# SECOND

RELIABILITY ASSESSMENT

ORBITING GEOPHYSICAL

PRC R-276

EXHIBIT 19 – MODE TRANSITION LOGIC CIRCUITS

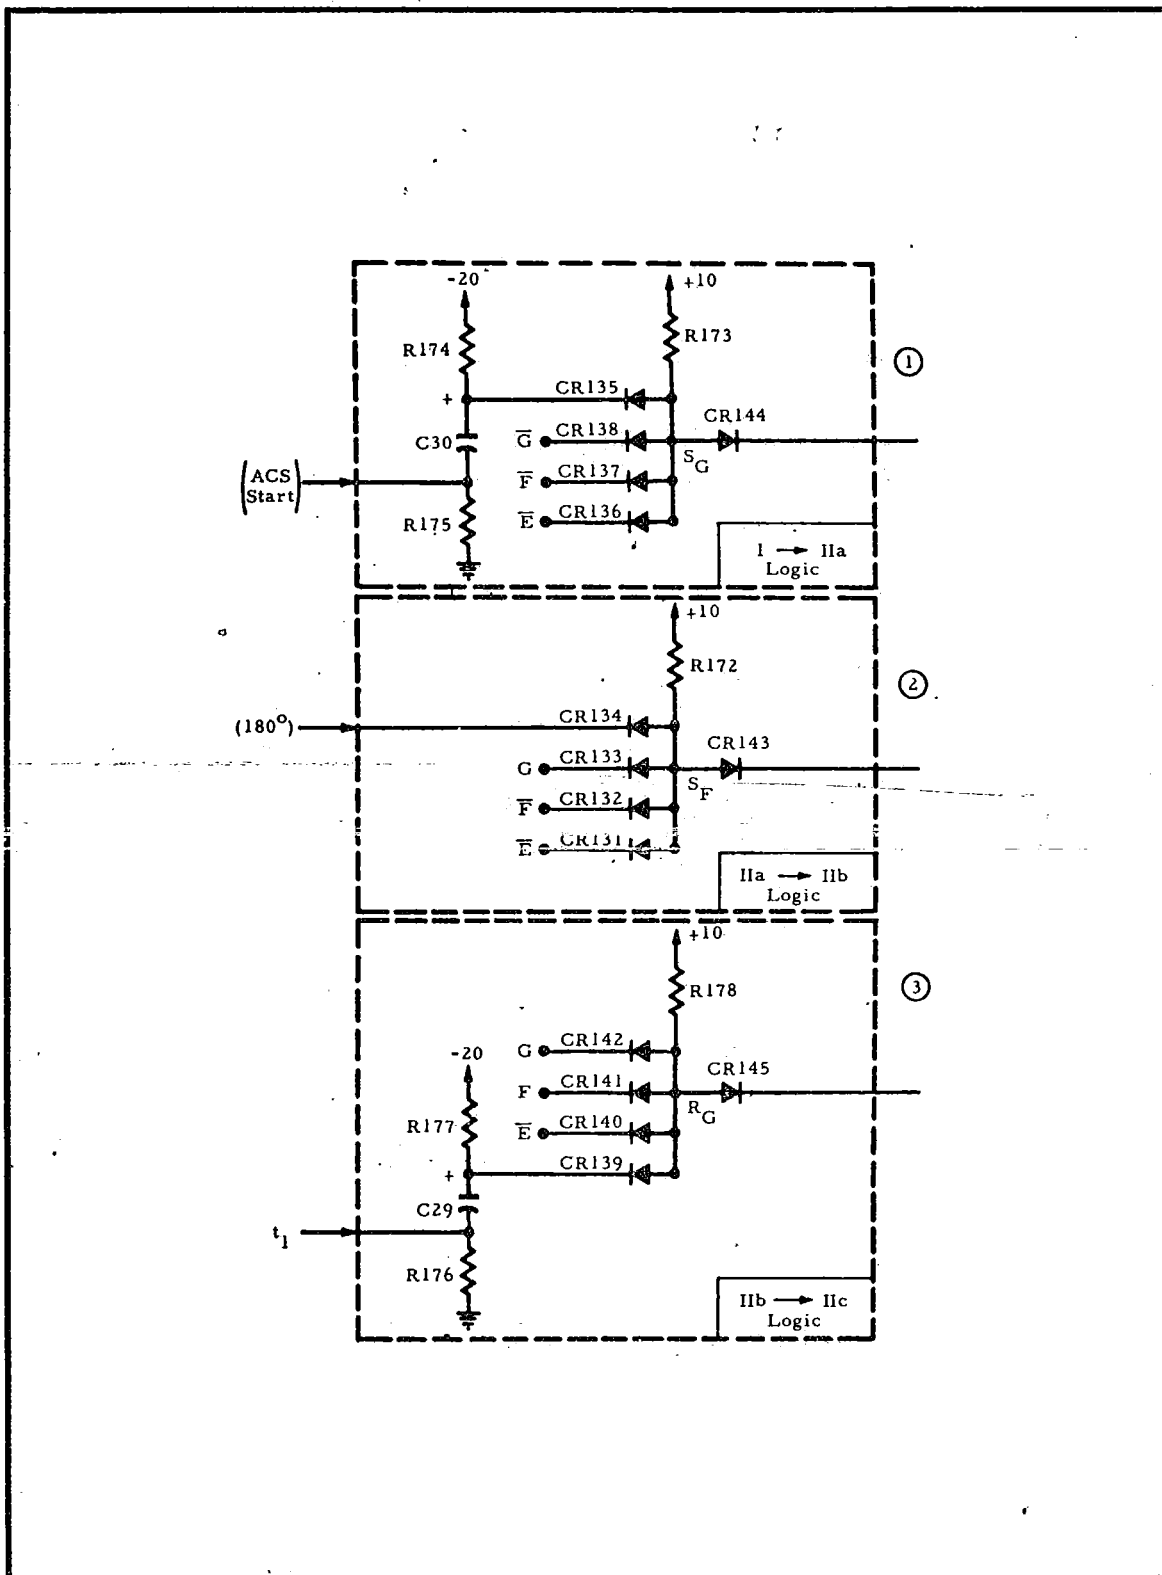
Within the present sensor electronics and logic assembly, the use of redundant piece parts is nonuniformly applied, with the resultant compromise of intended reliability. Specifically, in Z28 (Drawing 203707), there are four 3-input "diode" AND gates. Each diode is actually two 1N485-B diodes in electrical series connection. The output of each AND gate is fed to one input of a five-input diode OR gate. Each diode is actually two 1N485-B series-connected diode chains in parallel, using a total of four diodes. The output of this OR gate (through an inverter stage consisting of Q53 and associated resistors) drives one input of a three-input diode AND gate. These diodes are bona fide single diodes of type 1N485-B. The observation here is that the diodes of logic gates driving logic gates should individually have the same strength (reliability-wise) or the chain strength is essentially that of the weakest link.

It is recommended that use of redundancy on a "piece parts" basis should be investigated for all the diodes and resistors on the TB2 (203885) board. These elements function to distribute the "states" of the mode memory to various addresses; they are crucial elements. Also, use of redundancy in mode-sequencing logic should be investigated. Exhibit 19 shows three portions of the mode-sequencing logic. The upper box shows the circuits which produce a "true" output pulse when in Mode I (i.e., $E \cdot F \cdot \overline{G}$) and the ACS start pulse appears. This pulse advances the mode memory to Mode IIa (i.e., $E \cdot F \cdot G$). When the array slew operation is completed, the (180°) signal arrival produces a true output pulse to advance the mode memory to Mode IIb (i.e., $\overline{E} \cdot F \cdot G$). When the pulse t_1 is produced 29 minutes (nominal) later, a true output pulse advances the mode memory to Mode IIc (i.e., $\overline{E} \cdot F \cdot \overline{G}$). Since the present IIc → III sequencing logic will be discussed later, the reason for suggesting the use of piece-parts redundancy in the basic circuitry of Exhibit 19 is as follows: The logic discussed in Recommendation 3 (i.e., the THANT logic) is, reliability-wise, "strong." This strength is twofold. First, the probability of the THANT logic producing a true output (when "true" is logically valid) is high. Second, the probability of not producing a true output (when "untrue" is logically valid) is very small. Yet, the strong THANT logic only initiates a reacquisition cycle. The subsequent mode-sequencing progression
